Addendum to the EIA for Shendra Mega Industrial Park, Aurangabad Maharashtra

2. Reason for the Addendum

3. Changes proposed in the Plan

Figure 3-1: Green Areas - Revised

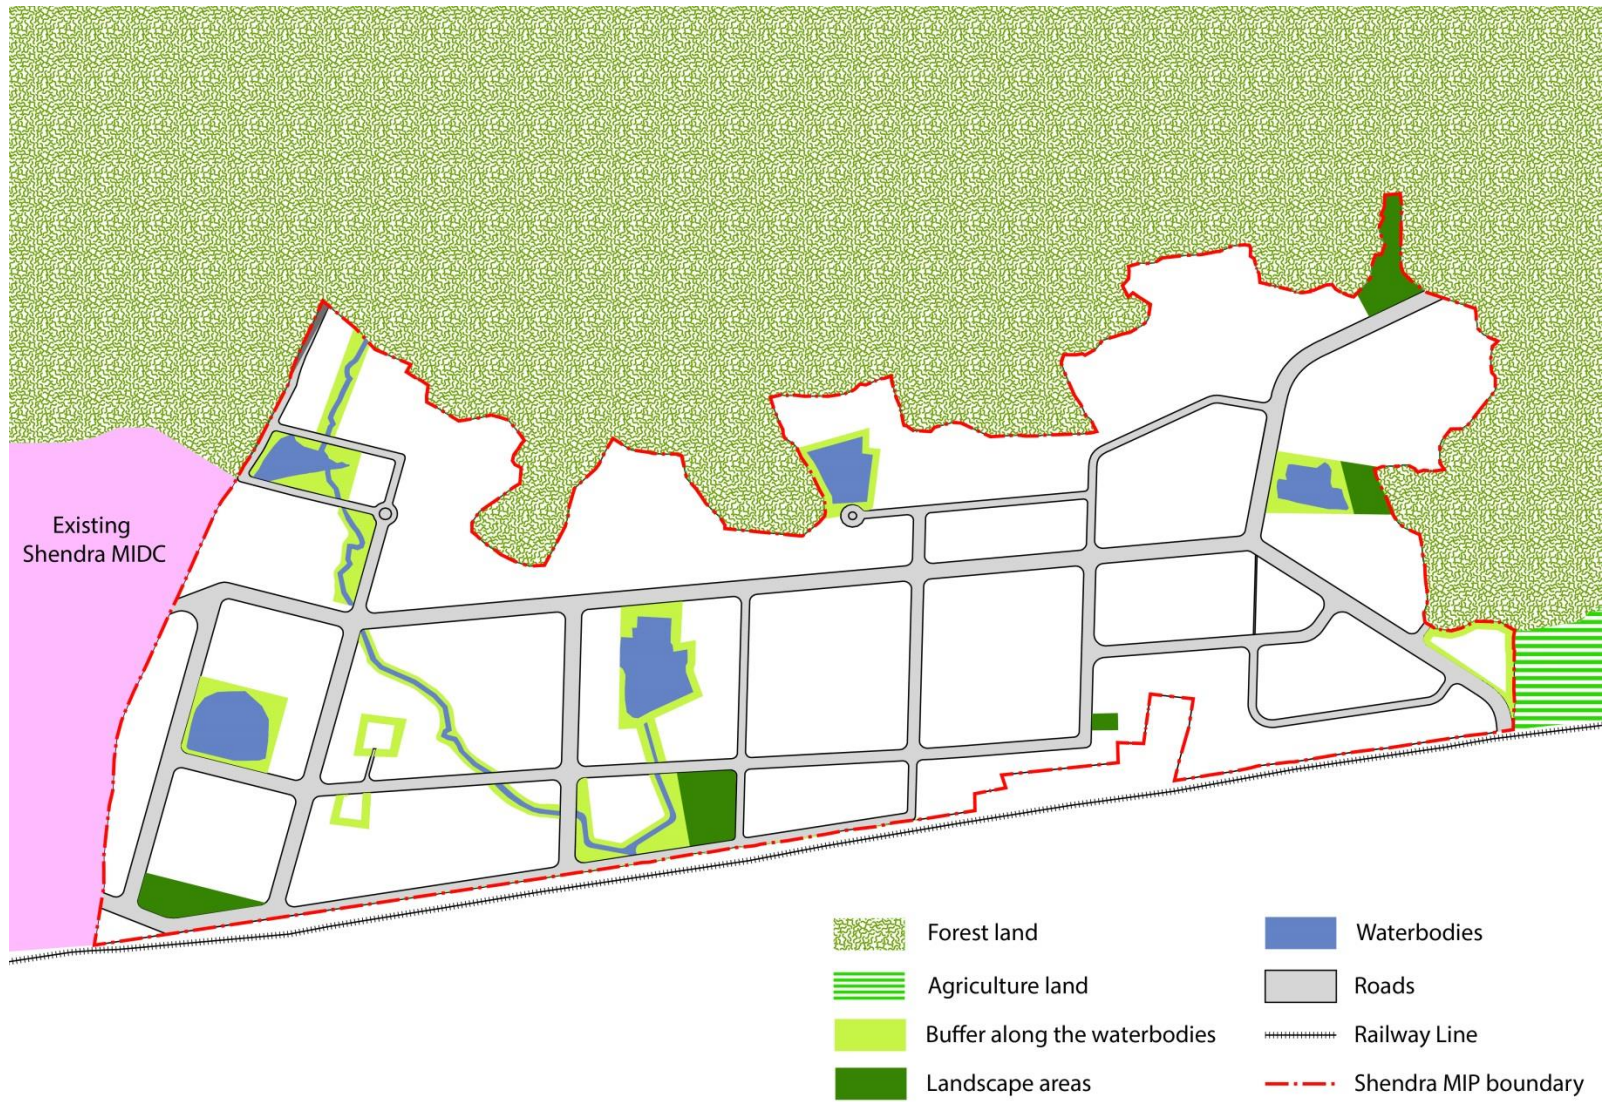
A 30 m wide buffer for Over-head high tension line was planned along the main spine and about 50 ha of park and green areas were proposed in the concept plan. The EC conditions also required a green belt of minimum width of 20m to be developed all around the project boundary.

However, in the revised plan, the High tension lines is to be buried and therefore buffer on the both sides of the HT Line is not required. The total Open space planned within the Shendra Industrial Park is 86.4 ha, of which:

- Area under green belts is : 37.31ha
- Area under parks and landscaped areas is : 17.77 ha
- Area under water bodies is : 31.35ha

The 20m buffer around the project boundary will not be required and hence it is requested to be removed. The reason for the same is:

- The northern boundary of the site is forest land and this entire length of 11.01 km is a natural green buffer with no development potential.
- The southern boundary of the plot is adjacent to a rail corridor and the right of way of the rail corridor will also act as a buffer to any development on the other side of the rail line.
- The western edge of the proposed site is adjacent to the existing Shendra MIDC so the uses are similar and there is no requirement for a buffer on the western side.
- In addition to the above, each of the allotted plots for industrial, residential etc. will have to maintain compulsory open space/green space within their plots as per the DC rules.
- However green belt/ buffer of adequate width will be provided between Industrial and Residential areas while preparing the detailed layout plans of different Zones.

PROPOSED DRAFT DEVELOPMENT PLAN FOR SHENDRA-BIDKIN SMART INDUSTRIAL CITY (PART-I; SHENDRA)

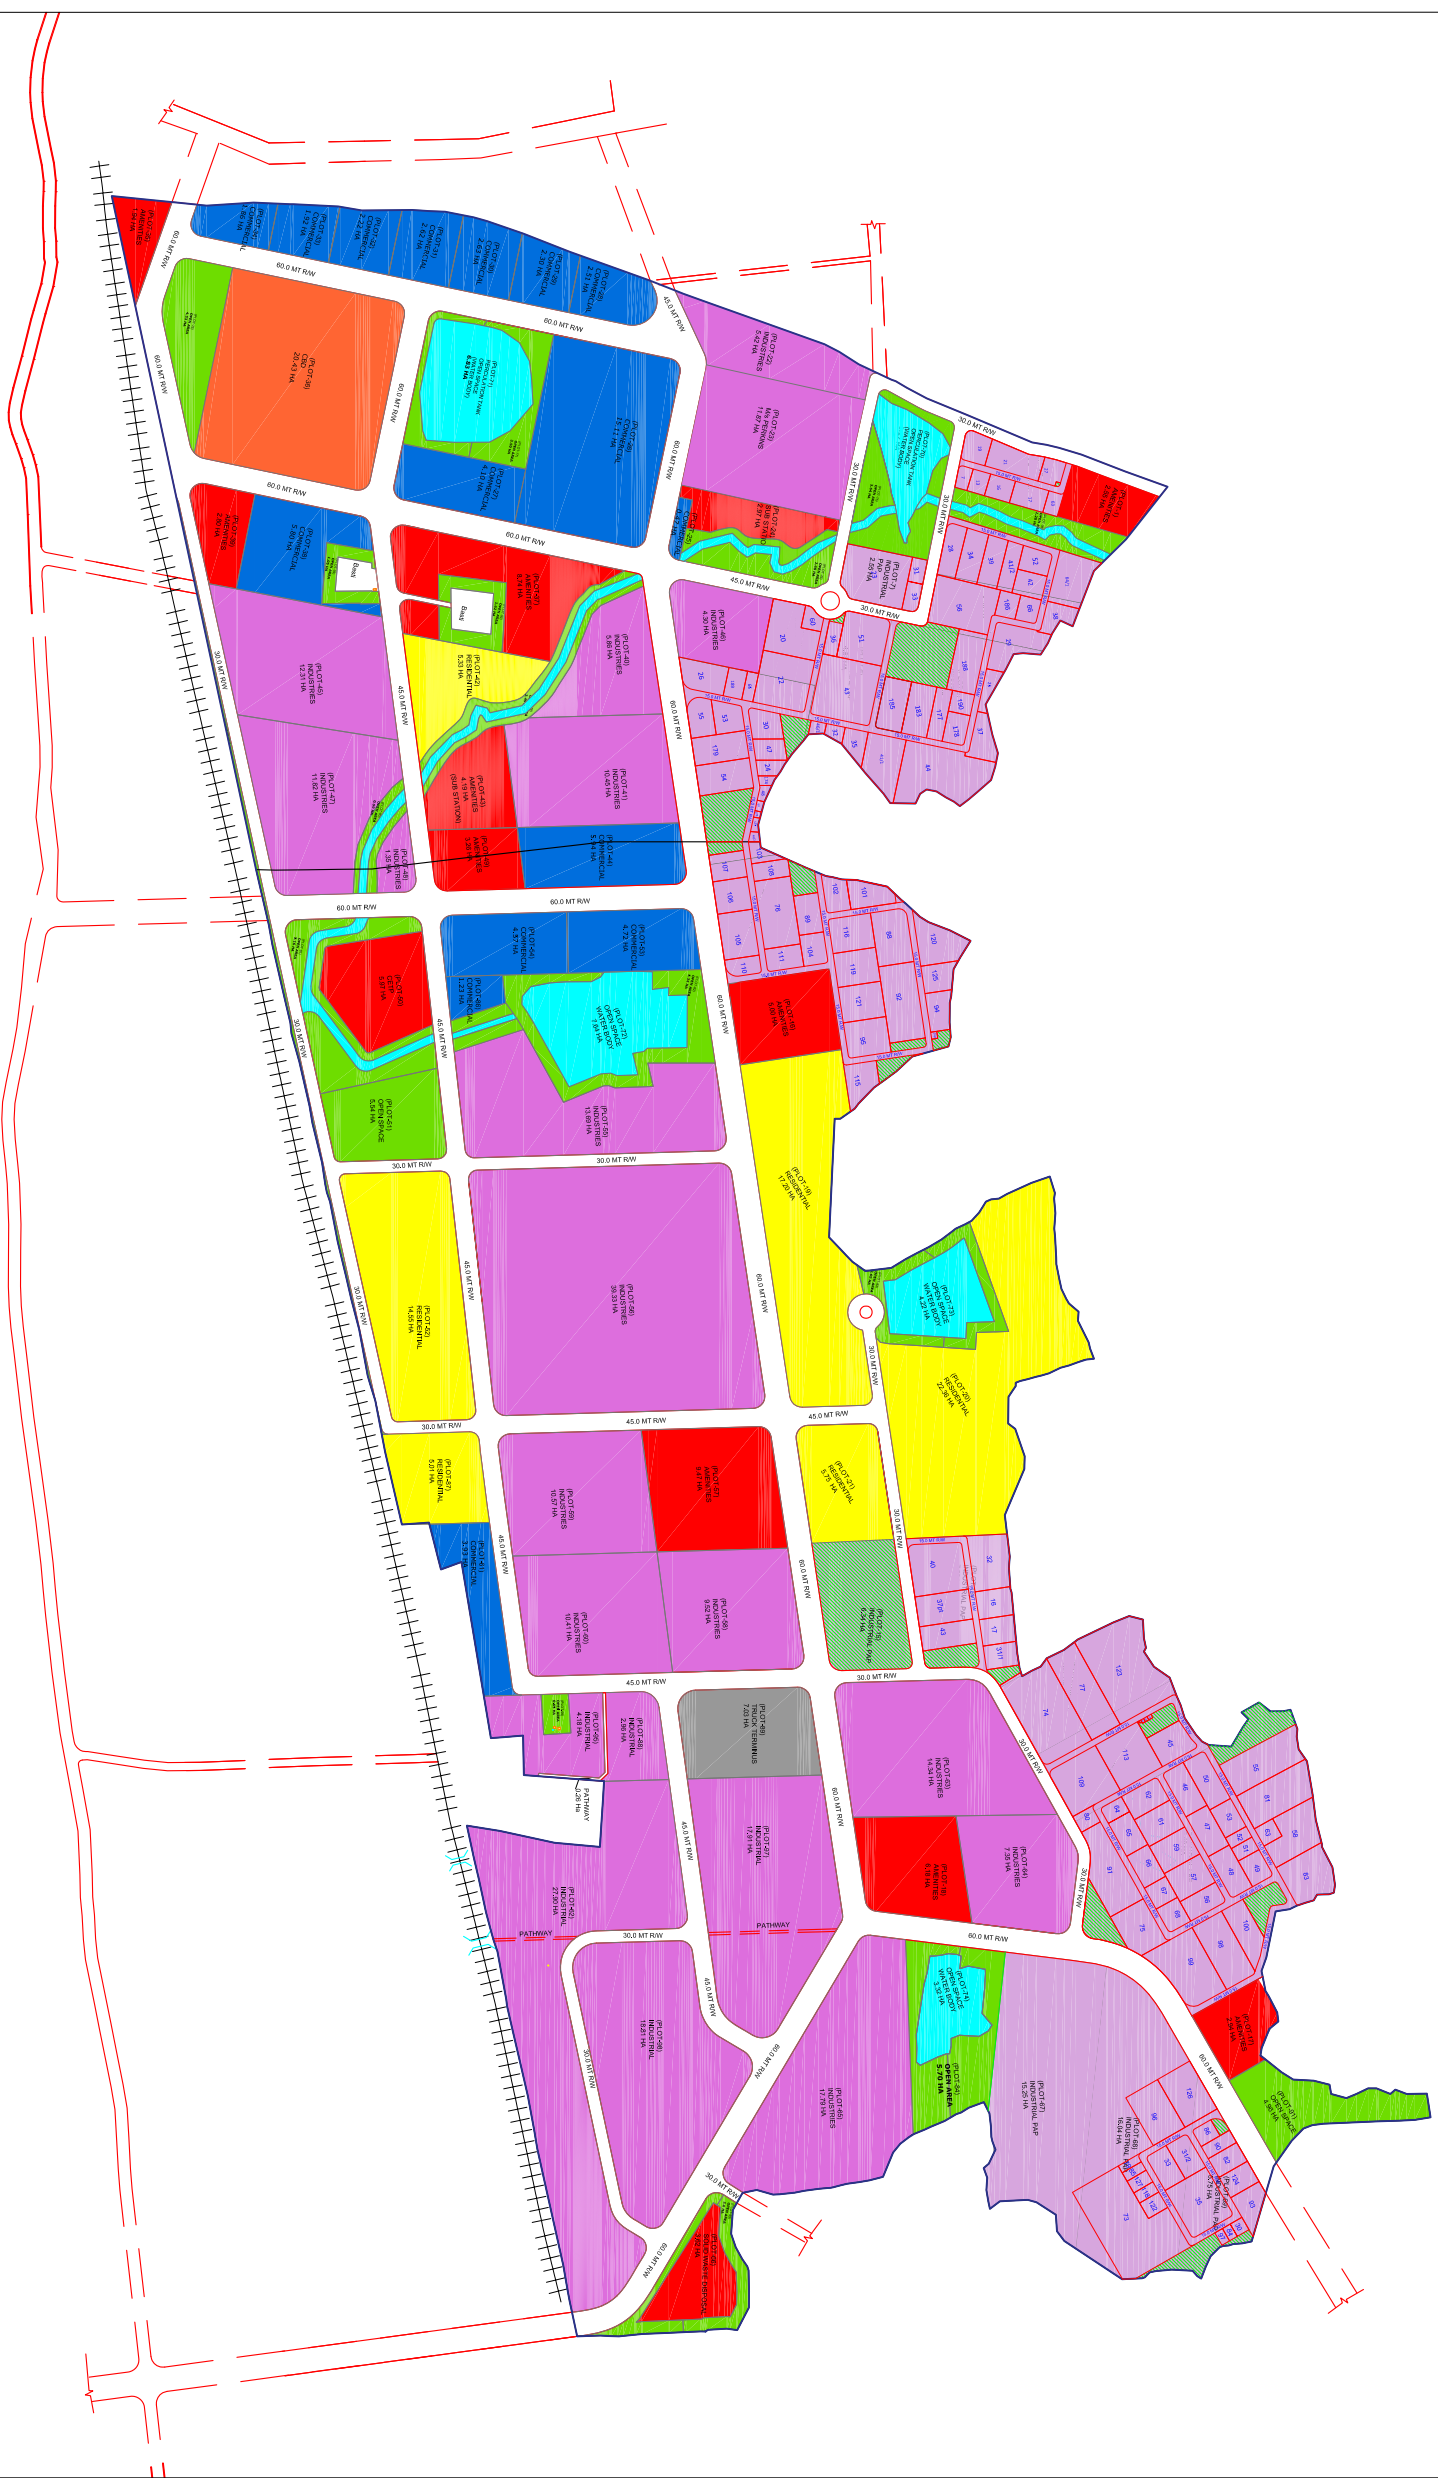
The change in land use is marginal for most of the aspects except the Industrial Area, which has been increased by about 4.44%. The land-use break-up for the site is based on the draft regulations for the Integrated Industrial Area (IIA) Clause 14.7 as per the draft Development Control Regulations (DCR) which indicates that the Planning Authority (in this case, MIDC) shall broadly allocate industrial

and related support activities in a proportion of 60% and 40% respectively (Please refer to the Revised Plan placed at **Annexure 'A'**).

- There is marginal increase in residential land use (about 2%), additional residential area is earmarked to promote housing facilities for the industrial workers within the Industrial area. This will help in curbing unauthorised development of slums around Industrial park.

- The green open space is reduced by (2.3%); this is because green open space as on both sides of high tension line is not required, as the high tension wires will be laid below the ground. This has not only improved the circulation pattern and transport network but also better utilisation of the land.

- The area under roads has also been reduced (about 4%), this is because the width of the spine road has been reduced from 90m to 60m based on the IRC guidelines and DCR requirements.

- The Industrial and Commercial areas has been increased by 4.44% and because area saved by laying underground HT Line and improvement of road network. This has improved the financial viability of the project.
